ADDENDUM #4
INVITATION FOR BID #22-01

NECP Building Renovation Project (Re-bid)

THIS ADDENDUM IS TO: ESTABLISH ALLOWANCE FOR ELEVATOR SUBTRADE WORK AND ANSWER THE QUESTIONS BELOW:

Drawing A202 - Please provide an elevation of the partitions.

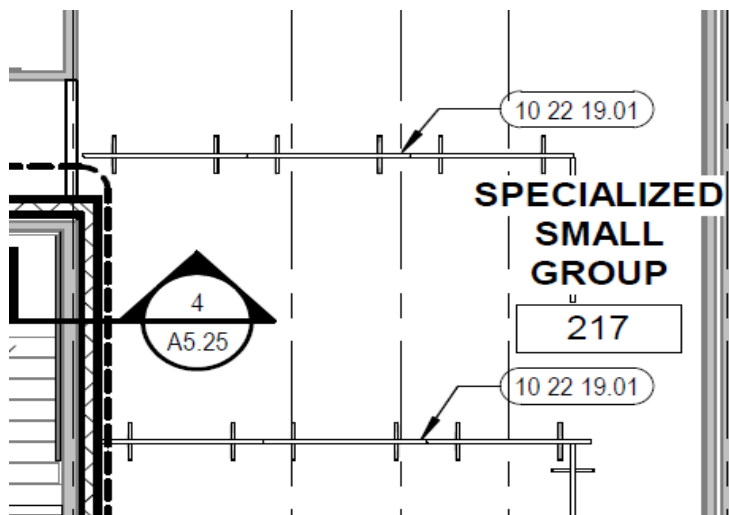
Q9. Please answer the following questions.

A9. See attached Addendum 4: Changes to Project Manual; Specification Section 102219, Part 2.1.A.2.a "partitions are to be 72" Tall."
